March 24, 2026

Re: Santa Maria Community Services
Project No. 25109
Addendum No. 5

1
P500

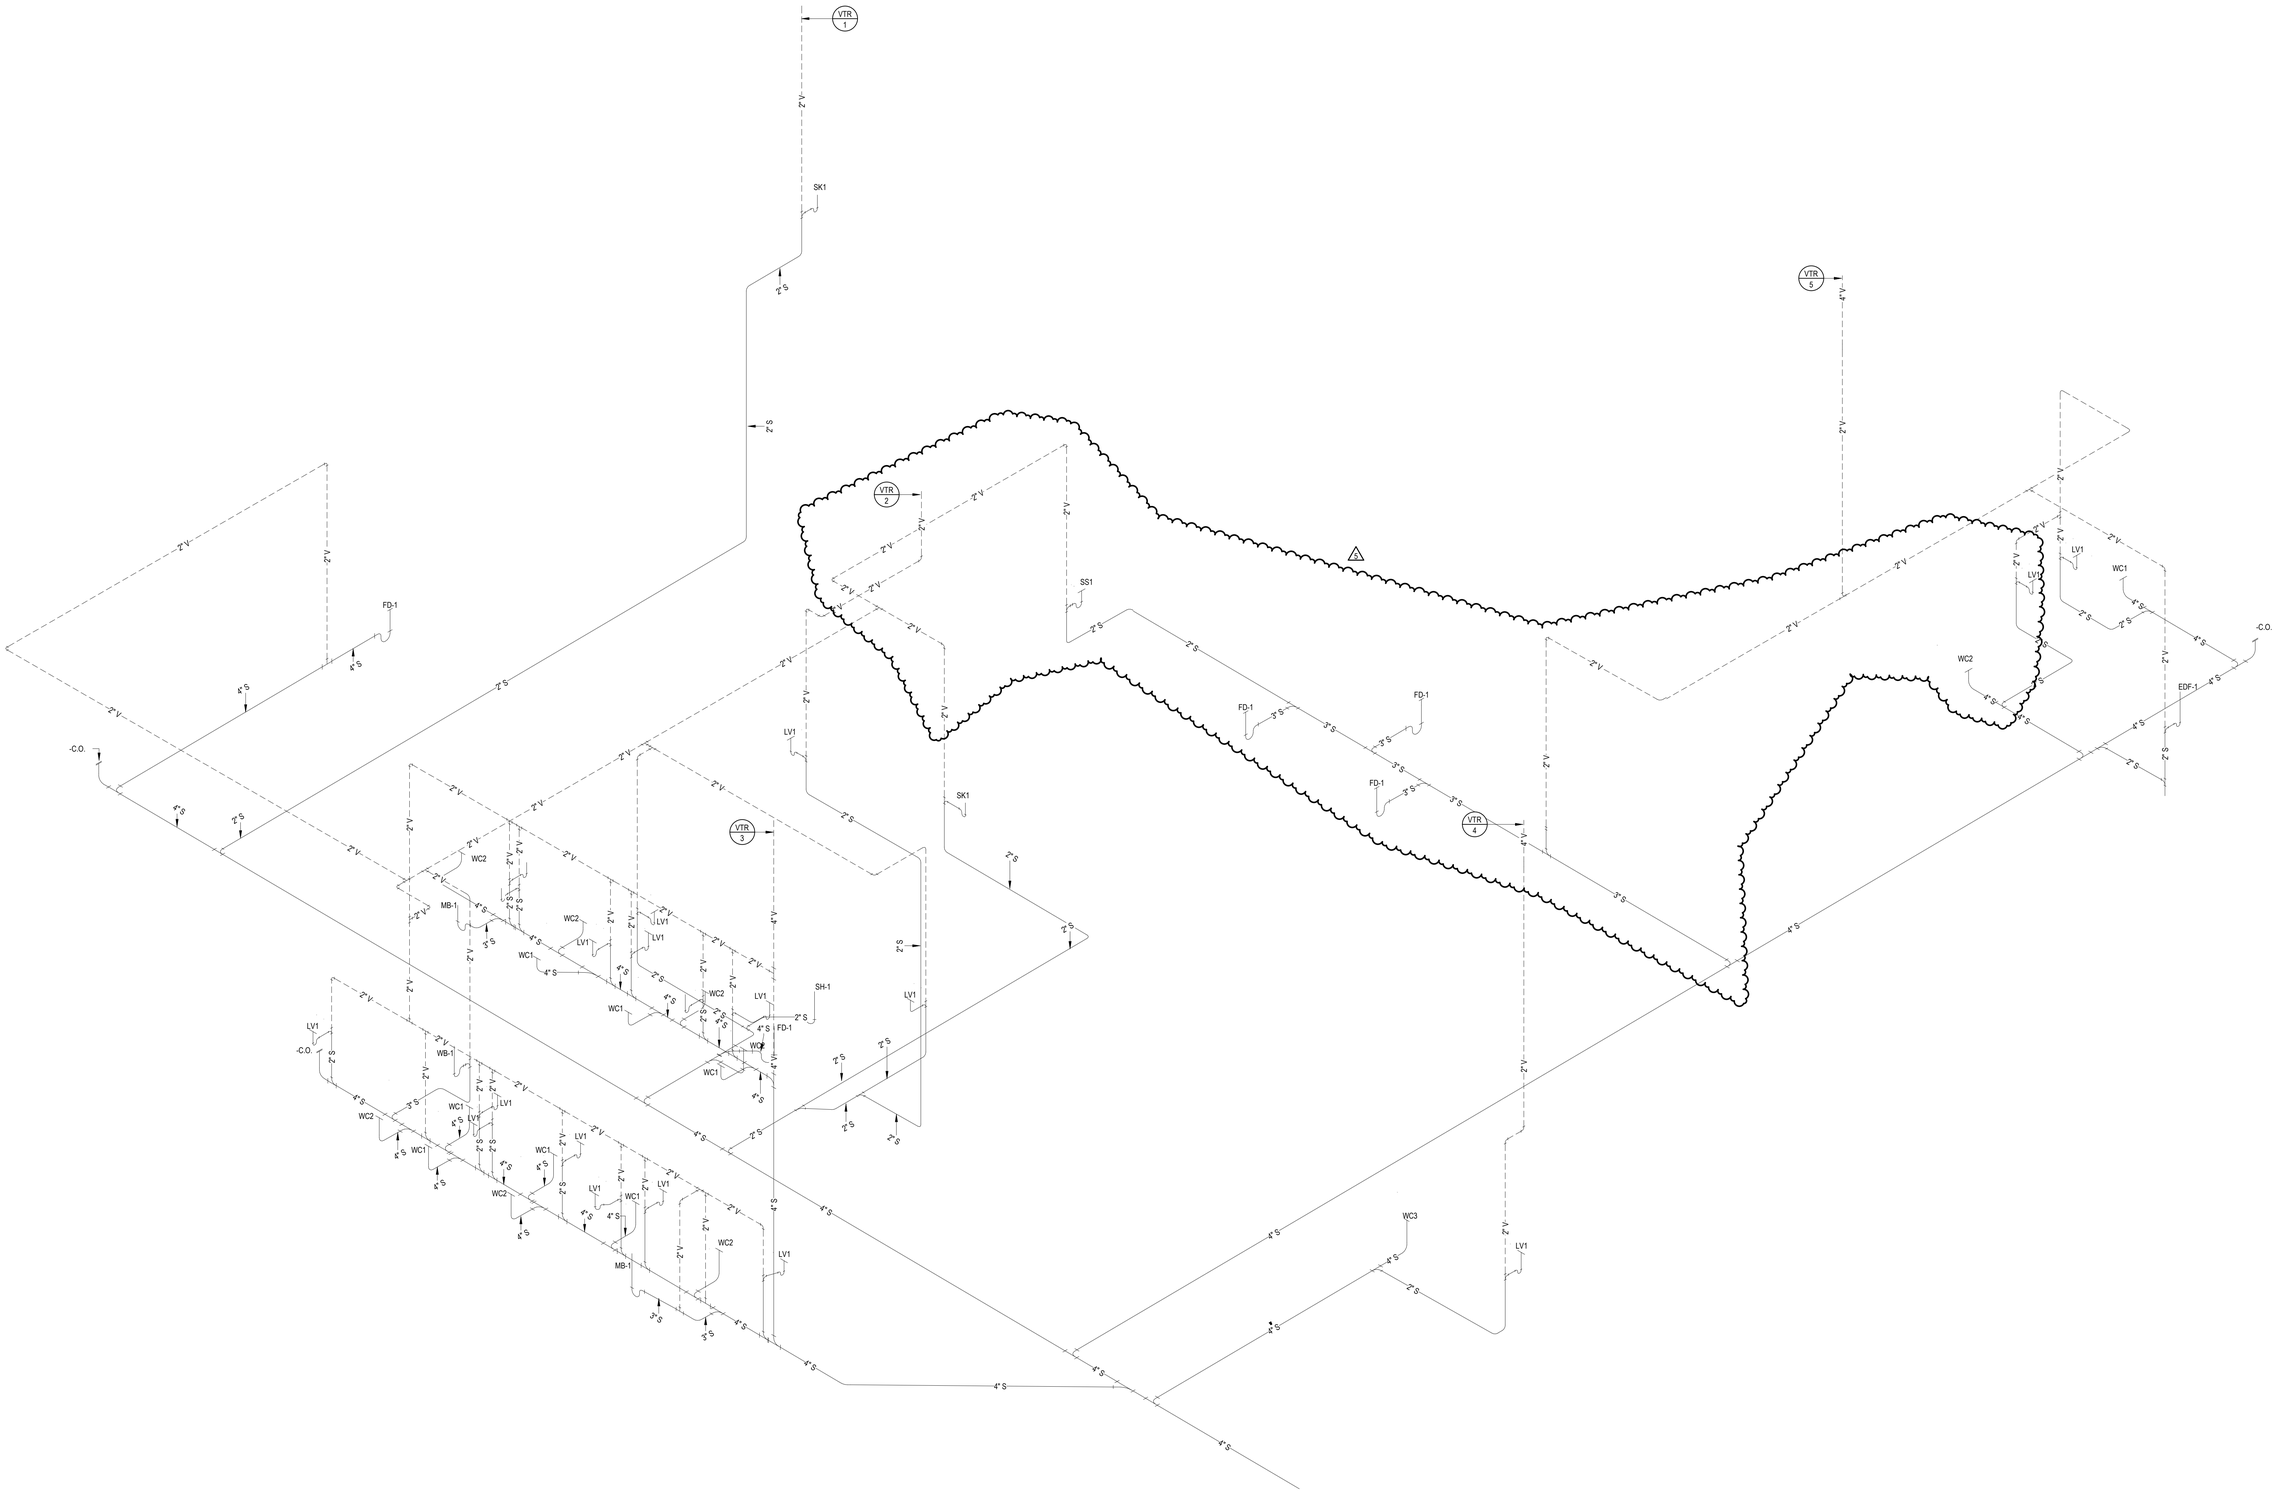
P500 Revised isometric to reflect all changes.

1 M101 MECHANICAL FIRST FLOOR PLAN

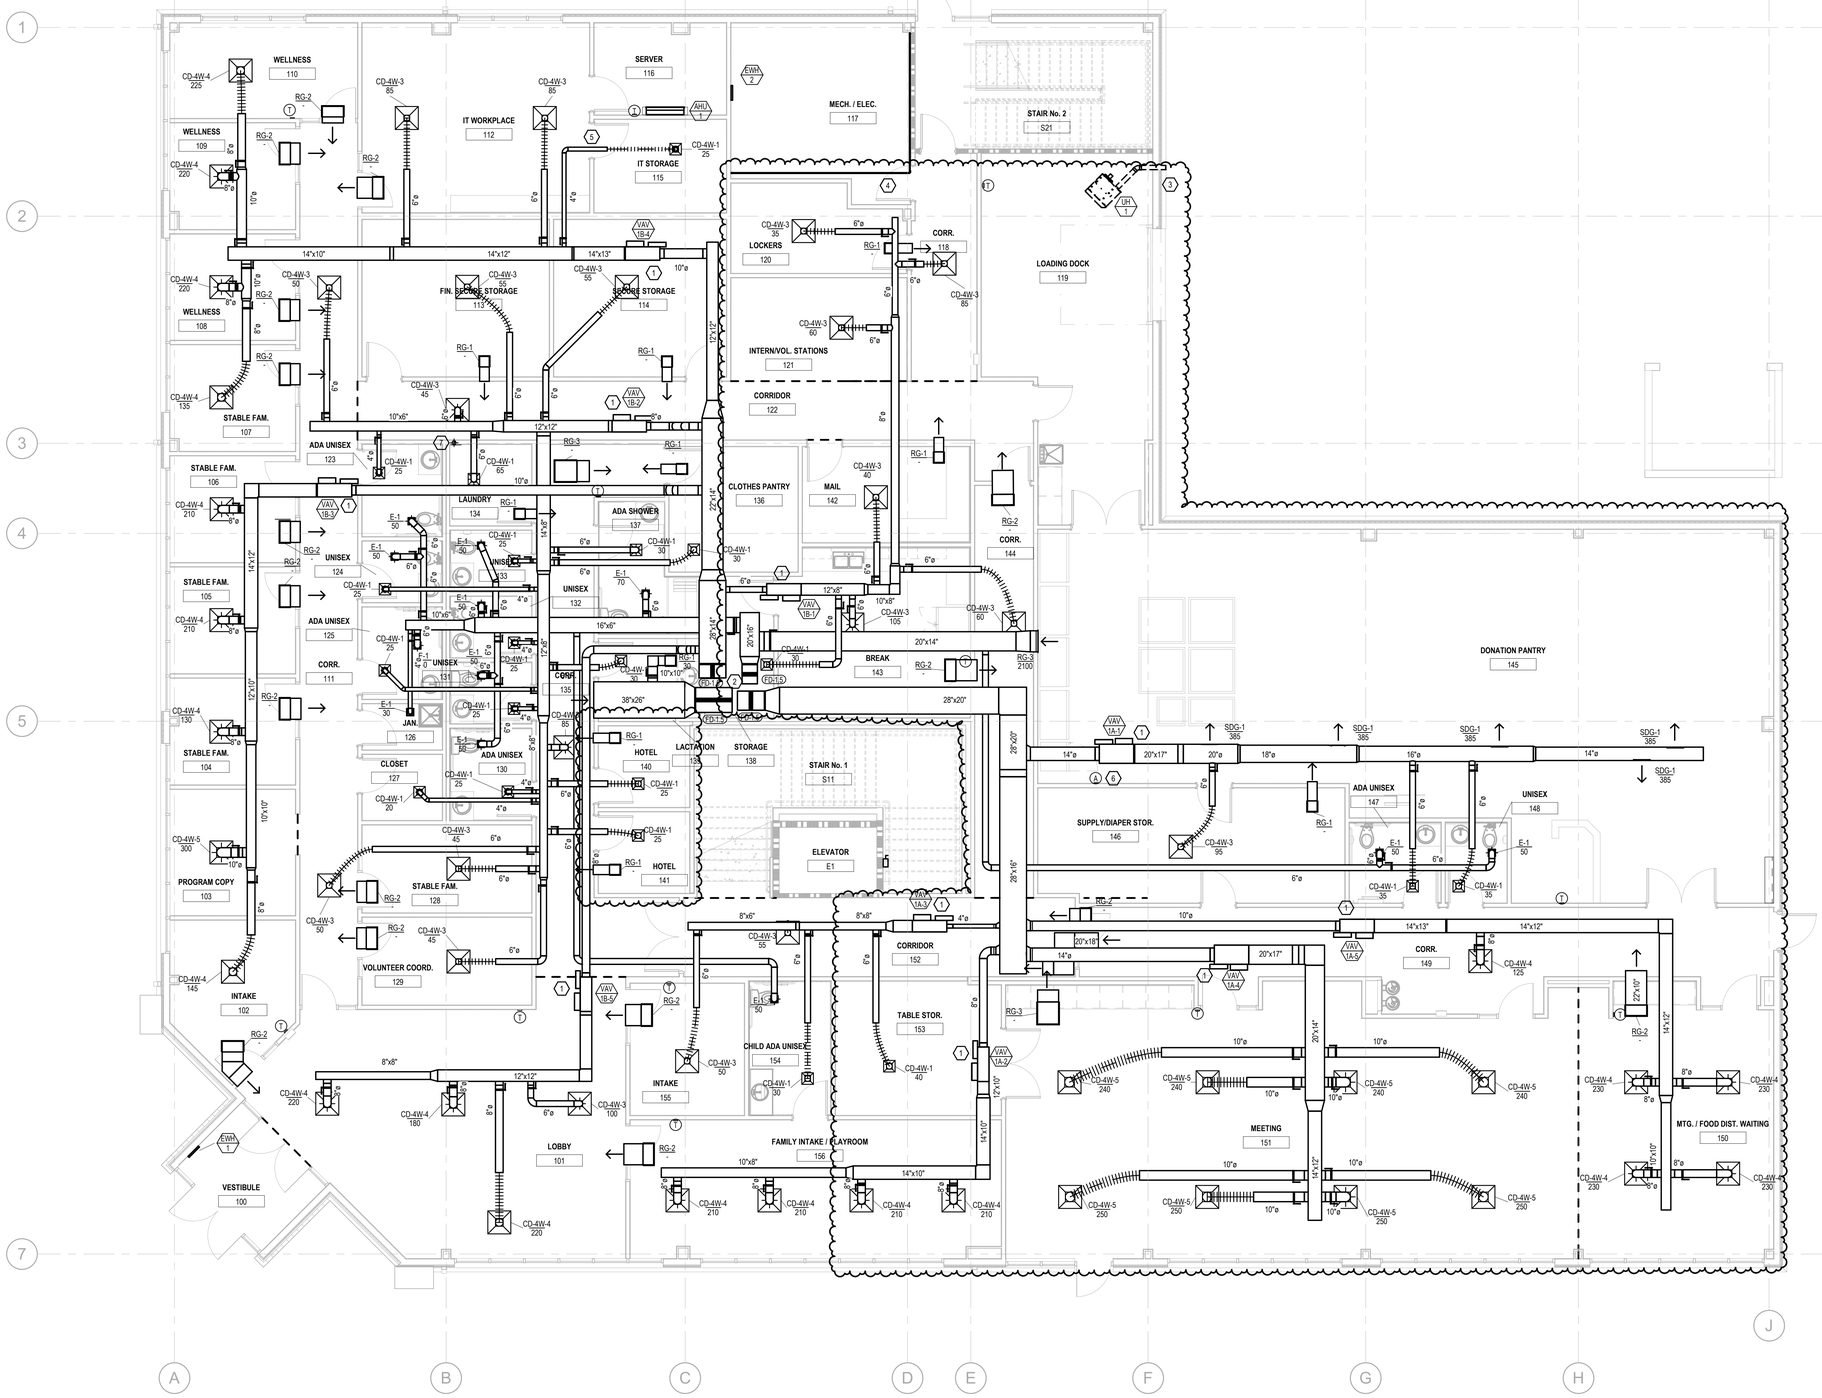
M101 Updated Zoning and reroute/resized ductwork to match floor plan changes.

1 FIRST FLOOR - POWER NEW
E101
3/16" = 1'-0"

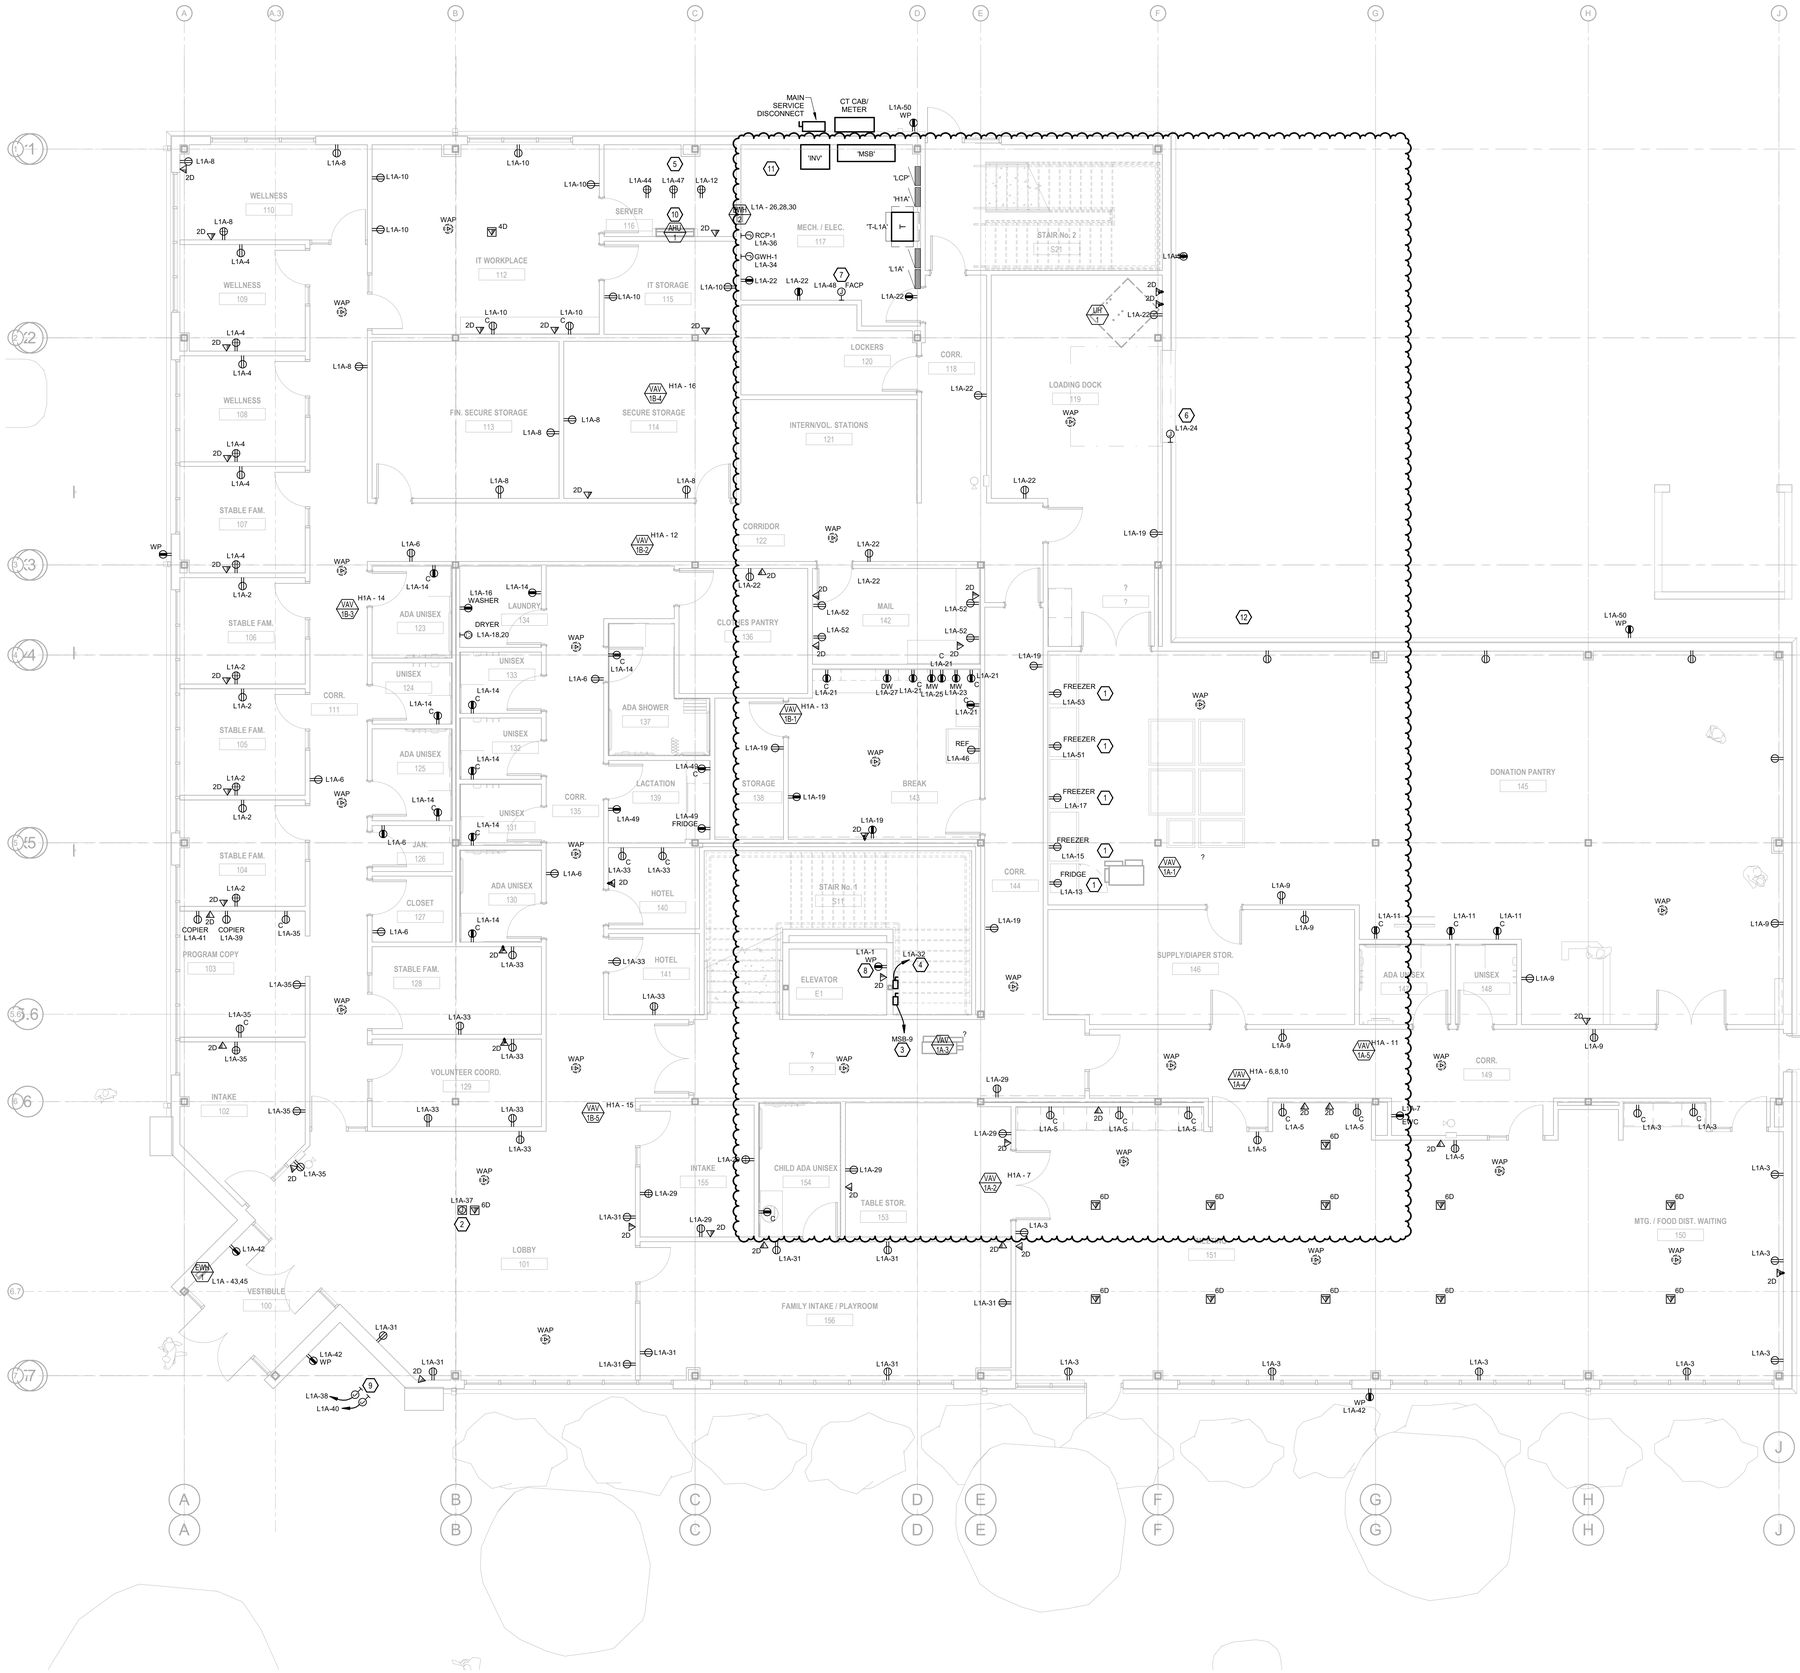
E101 Relocated various receptacles to accommodate floor plan changes.

Added freezer circuits in Donation Pantry #145.

Added key note #12 for future exterior coolers.
